# HISTORIC AND DESIGN REVIEW COMMISSION

**HDRC CASE NO:** 2017-467  
**ADDRESS:** 423 N HACKBERRY ST  
**LEGAL DESCRIPTION:** NCB 576 BLK 15A LOT N 30.32 FT OF 12  
**ZONING:** RM-4 H  
**CITY COUNCIL DIST.:** 2  
**DISTRICT:** Dignowity Hill Historic District  
**APPLICANT:** John Brearley  
**OWNER:** John and Irene Brearley  
**TYPE OF WORK:** New construction of a 2-story single family home  
**APPLICATION RECEIVED:** October 17, 2017  
**60-DAY REVIEW:** December 16, 2017  
**REQUEST:**

The applicant is requesting conceptual approval to construct a new two-story single family home on the vacant lot at 423 N Hackberry.

LEFT ELEVATION

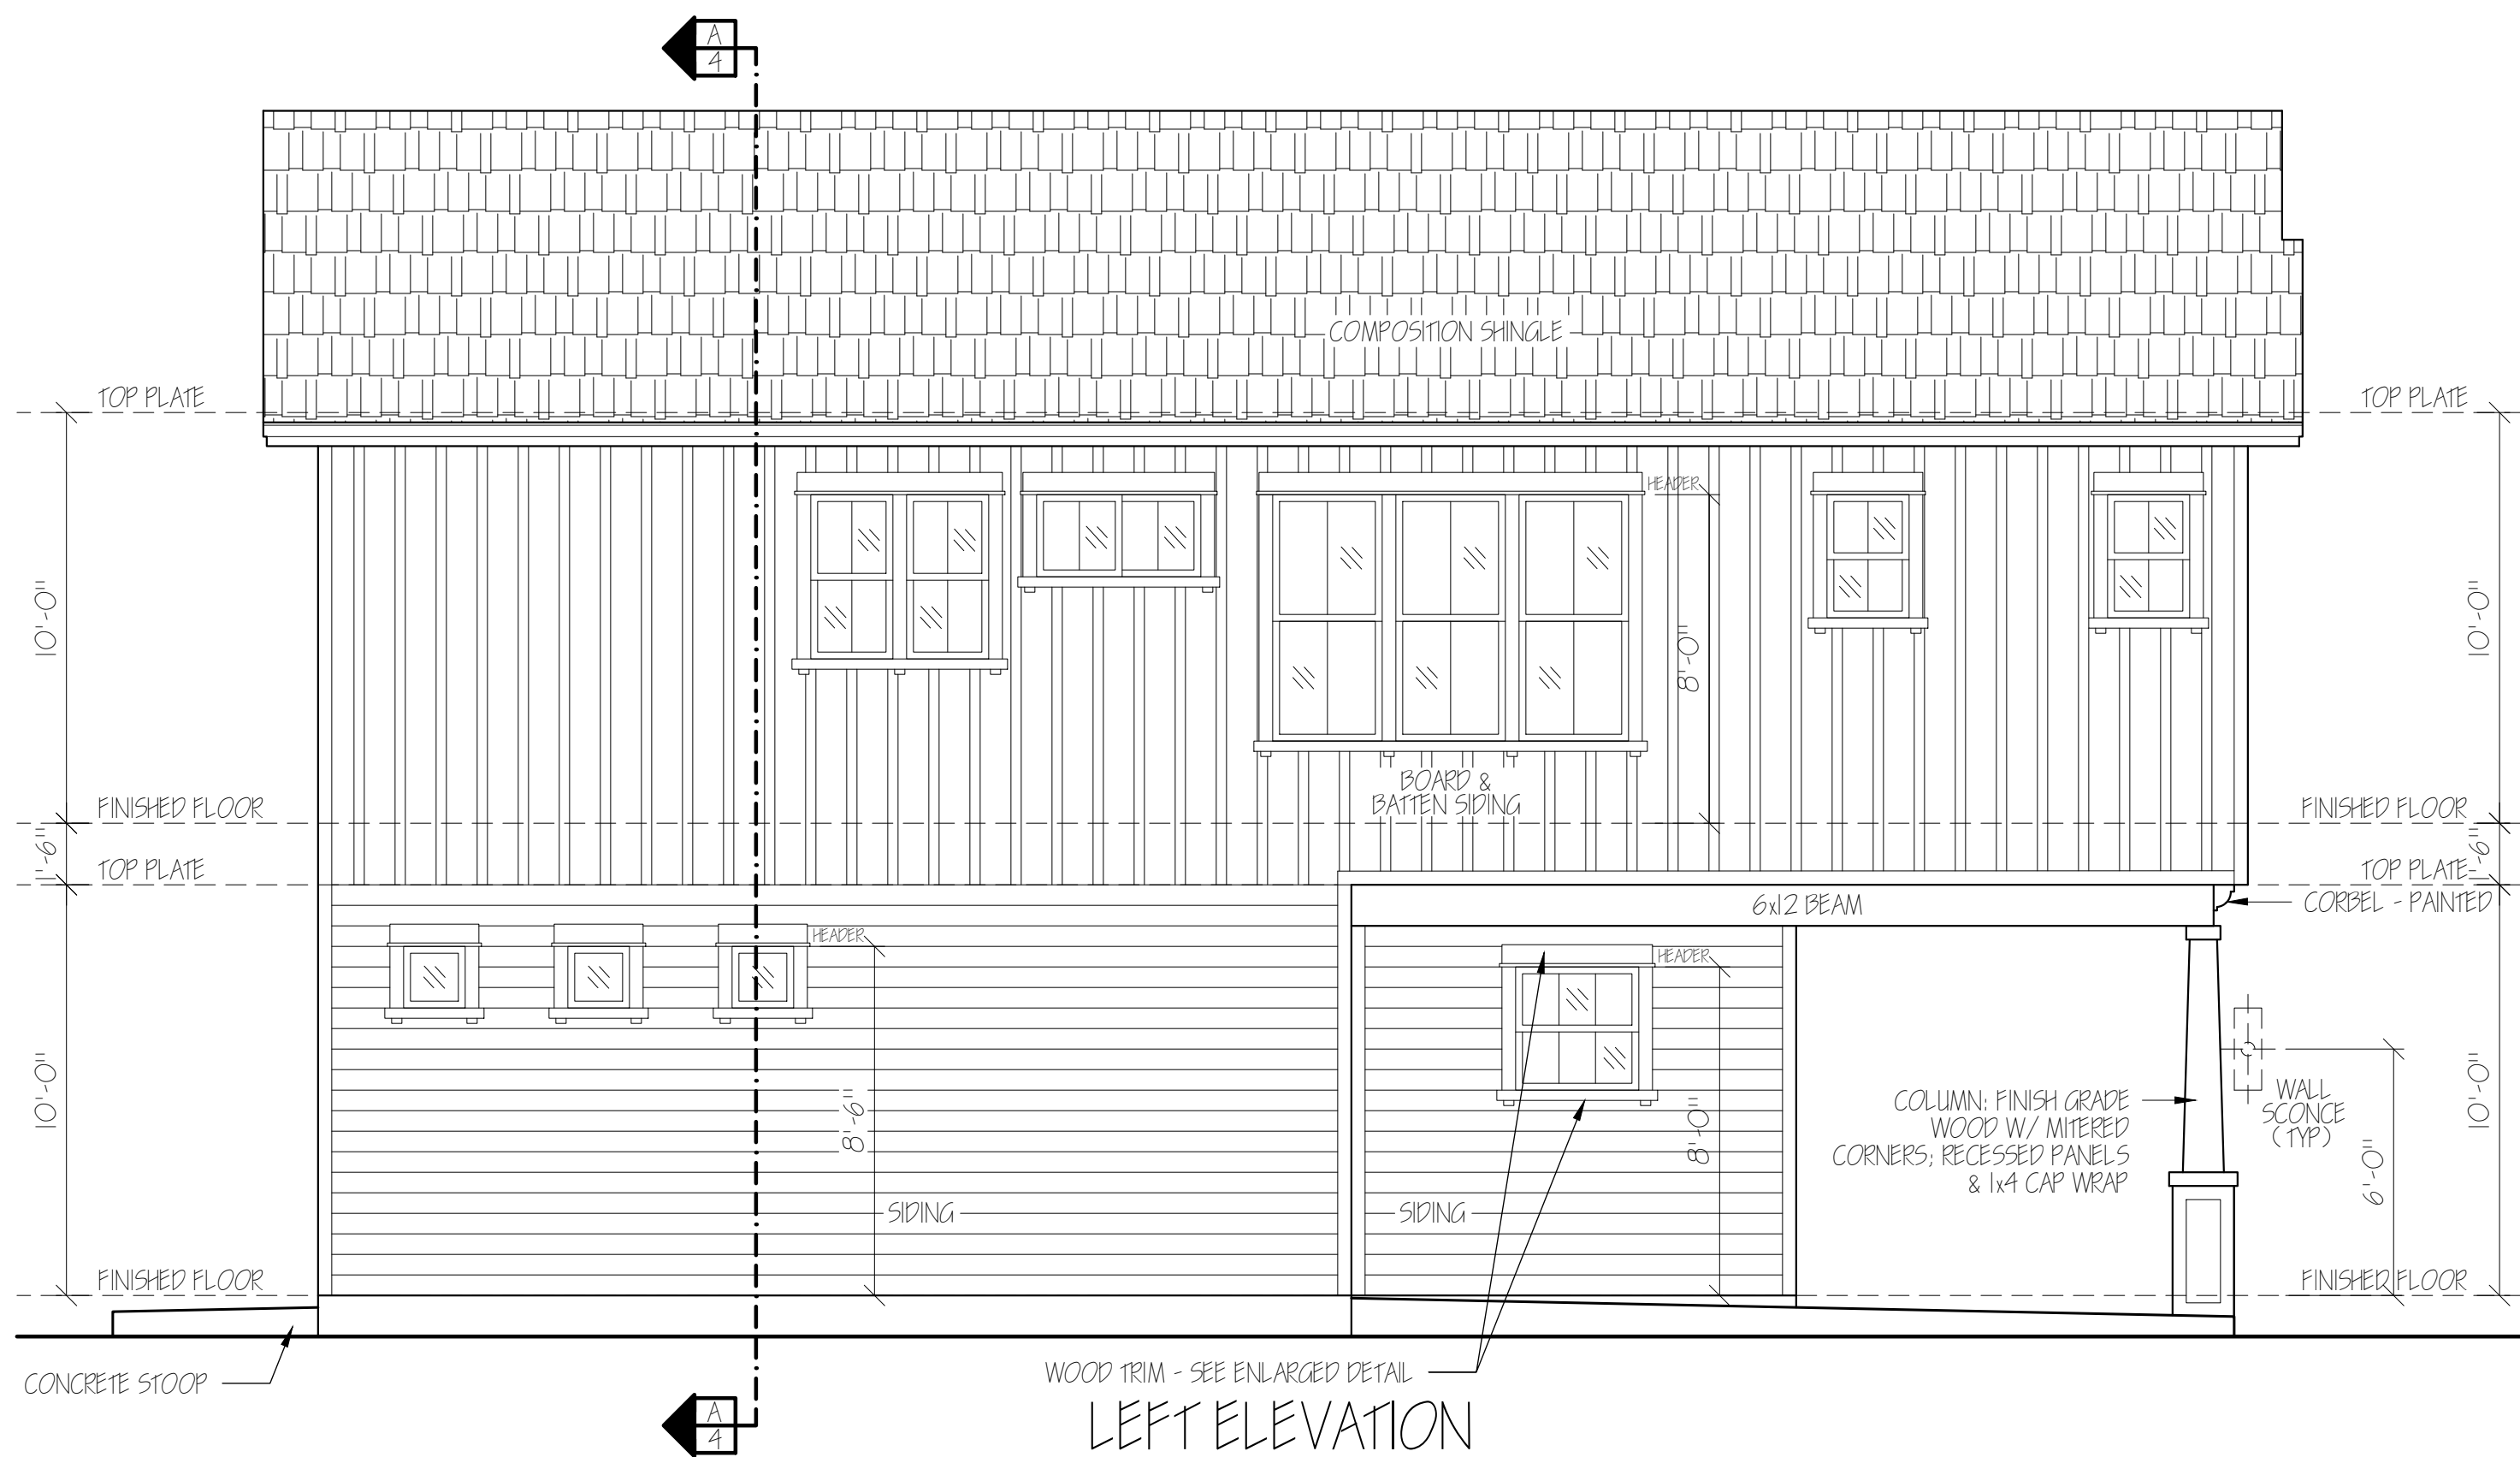
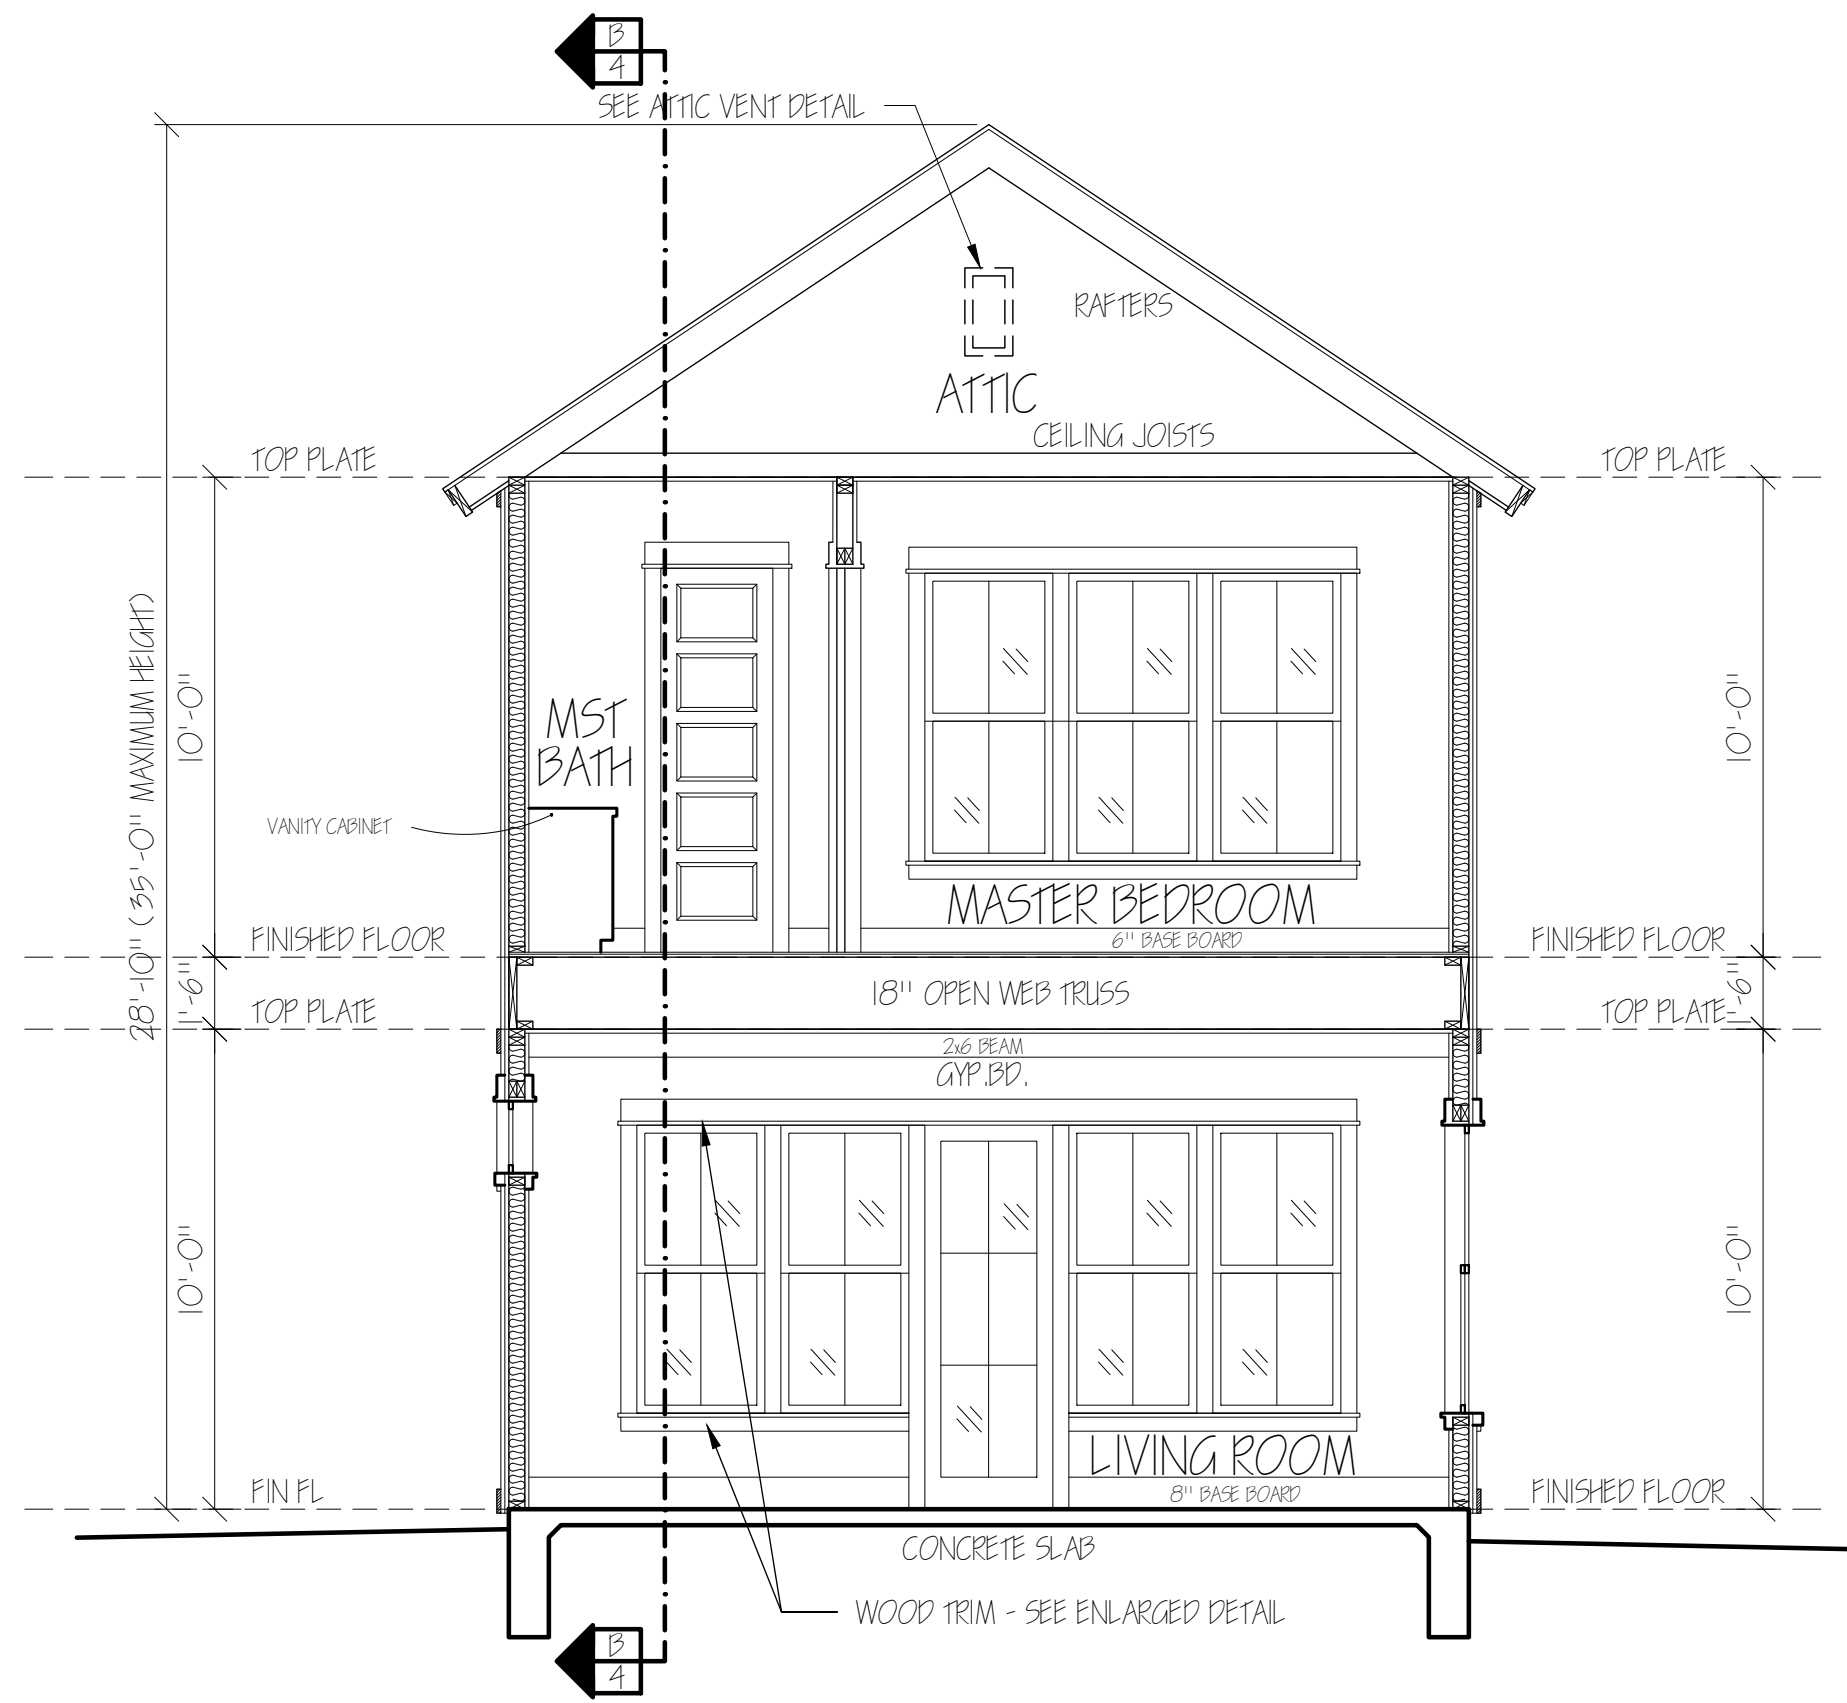
- f. **SCALE & MASS** – Per the Guidelines for New Construction 2.A.i., a height and massing similar to historic structures in the vicinity of the proposed new construction should be used. In residential districts, the height and scale of new construction should not greatly exceed the historic precedent. The only remaining historic residential structure on N Hackberry between E Houston and Glorietta is 2 stories. The remaining historic structures in the vicinity on Glorietta are 1-story. The applicant has noted on the submitted drawings that the proposed ridge line will be 28'-10" from the finish floor, which is approximately one foot from grade, bringing the total height to approximately 29'-10" feet. Both the first and second stories will feature 10'-0" tall interior ceiling heights separated by a web truss measuring 1'-6". The neighboring 2-story historic structure features a first floor ceiling height of 10'-0" and a second floor ceiling height of 8'-0". Staff does not find the proposed height to be consistent with the Guidelines. Staff finds that the overall height should be reduced through the shortening of the second story or the lowering of the top plate height to produce an overall height that is comparable with the heights of neighboring, historic structures.

- g. **PORCH CONFIGURATION AND MASSING** – The applicant has proposed to incorporate a front porch on the front façade of the new structure. The porch mass will be inset approximately 6" from the front façade. The Historic Design Guidelines state that porches on new construction should be reflective of the development pattern of the district. Typically in historic districts, including Dignowity Hill, residential porch massing elements project the furthest towards the streetscape to engage pedestrians. Two story structures feature a second story that is set back from the porch. As proposed, the structure's second story extends over the front porch, which increases the massing on the street. This is addressed in Guideline 2.A.ii, which states that step-downs in building height, wall-plane offsets, and other variations in building massing to provide a visual transition should be utilized. There is no historic precedent in the district for this porch form or massing strategy. Staff finds the porch inconsistent with the

- j. **WINDOW & DOOR OPENINGS** – Per the Guidelines for New Construction 2.C.i., window and door openings with similar proportions of wall to window space as typical with nearby historic facades should be incorporated into new construction. The applicant has proposed window and door openings that are generally consistent with those found on historic structures in regards to location and size with the exception of the right and left elevations, which feature several small fixed windows that are not consistent with the OHP Window Policy Document or historic fenestration precedents in the district, as well as a series of ganged windows with minimal trim separation between them. All proposed window detailing can be modified to relate closer to historic examples, such as the use of approximately six inches of separation between double windows. Each window should be inset at least two (2) inches within walls to ensure that a proper façade depth is maintained.

1. That the applicant provides information noting the setbacks of adjacent historic structures on a contextual site plan.
2. That the applicant reduces the proposed height through the shortening of the second story or the lowering of the top plate height to produce an overall height that is comparable with the heights of neighboring historic structures.

3. That the applicant sets the second story back from the front façade and modifies the front porch configuration and massing as noted in finding g. The porch should be the mass that projects furthest towards the streetscape to reflect the developmental context of the area.

4. That the proposed driveway extends along the side of the proposed new construction as noted in finding p.
5. That the applicant introduces window sizes and proportions that are more consistent with the Historic Design Guidelines, the OHP Window Policy Document, and adjacent historic structures to the right and left elevations as noted in finding i.

ROOF PLAN

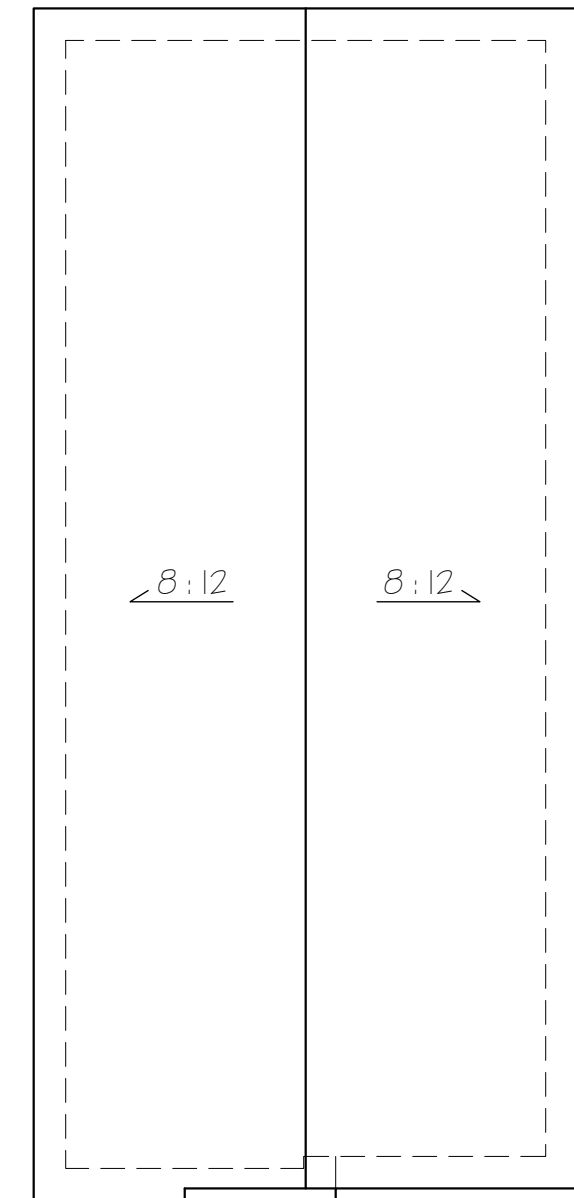
- i. **ROOF FORM** – The applicant has proposed a primary gable roof form with an additional front gable. There are historic examples of this roof form throughout the Dignowity Hill Historic District. Staff finds the proposed roof form generally consistent with the Guidelines.
